Program Bulletin

SB-10056217-5338

SUBJECT: Tail Lamp Gasket Seal

MODELS: 2014 Chevrolet Impala

3649621

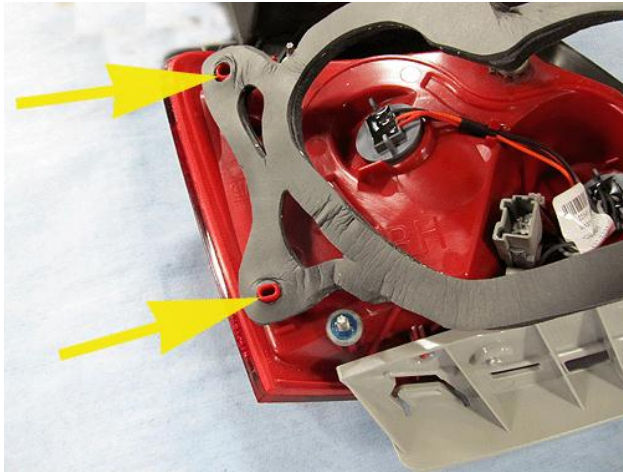
Note: Perform the seal replacement on both tail lamps

3. Place the tail lamp assembly on a soft work area to prevent damage to the outer lens area.

4. Slowly peel the seal away from the housing, using care to remove the adhesive from the housing. **Tip:** Removing the seal at a 45 degree angle while slightly stretching the rubber will remove most of the adhesive with the seal.

3649627

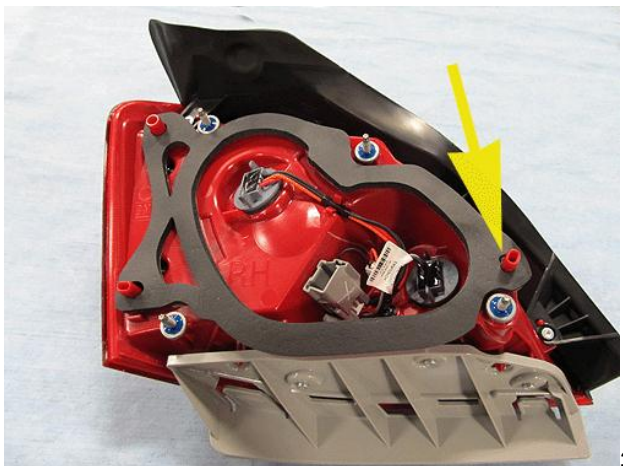
5. Clean any old adhesive from the tail lamp housing using a general purpose adhesive remover.
6. Start the new seal application by placing the two outer alignment pins through the holes on the seal. Ensure that the adhesive side of the seal is facing the tail lamp.

- 6.1 Install the seal, ensuring that it is centered on the compression ribs on the tail lamp housing as shown.
